Well Name: LOST TANK 3 FED	Well Location: T22S / R31E / SEC 3 / NENE / 32.4268844 / -103.7585353	County or Parish/State: EDDY / NM
Well Number: 6	Type of Well: OIL WELL	Allottee or Tribe Name:
Lease Number: NMNM0417696	Unit or CA Name:	Unit or CA Number:
US Well Number: 3001531887	Operator: OXY USA INCORPORATED

Sundry ID: 2853995  
Type of Submission: Notice of Intent  
Date Sundry Submitted: 05/21/2025  
Date proposed operation will begin: 05/21/2025  
Type of Action: Plug and Abandonment  
Time Sundry Submitted: 06:41

LOST TANK 3 FEDERAL 006

NOI TO PERMANENTLY ABANDON THIS WELL VIA CEMENT PLUGGING.

**PROPOSED WELLBORE**

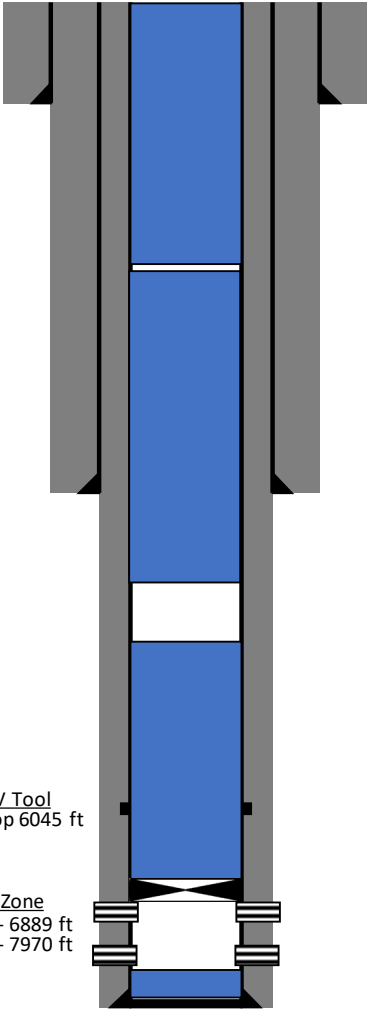
SPOT 34 SX CMT FROM 8253' TO 7988'  
WOC AND TAG WITH WIRELINE

\*Run CBL from CIBP to surface.

Submit results to BLM.

1. POOH WITH EXISTING 2-7/8" TBG AND BHA
2. SPOT 34 SX CL H CMT FROM 8253' TO 7988'. WOC AND TAG
3. SET CIBP AT 6821' VIA WIRELINE. LEAK TEST TO 500 PSI FOR 30 MINUTES
4. RUN CBL FROM CIBP SET AT 6821' TO SURFACE PER OCD REQUIREMENTS. REVIEW WITH BLM.
5. SPOT 206 SX CL C CMT FROM 6821' TO 5123'. WOC AND TAG
6. SPOT 276 SX CL C CMT FROM 4370' TO 2100'. WOC AND TAG
7. SPOT 255 SX CL C CMT FROM 2100' TO SURFACE
8. VERIFY CMT TO SURFACE
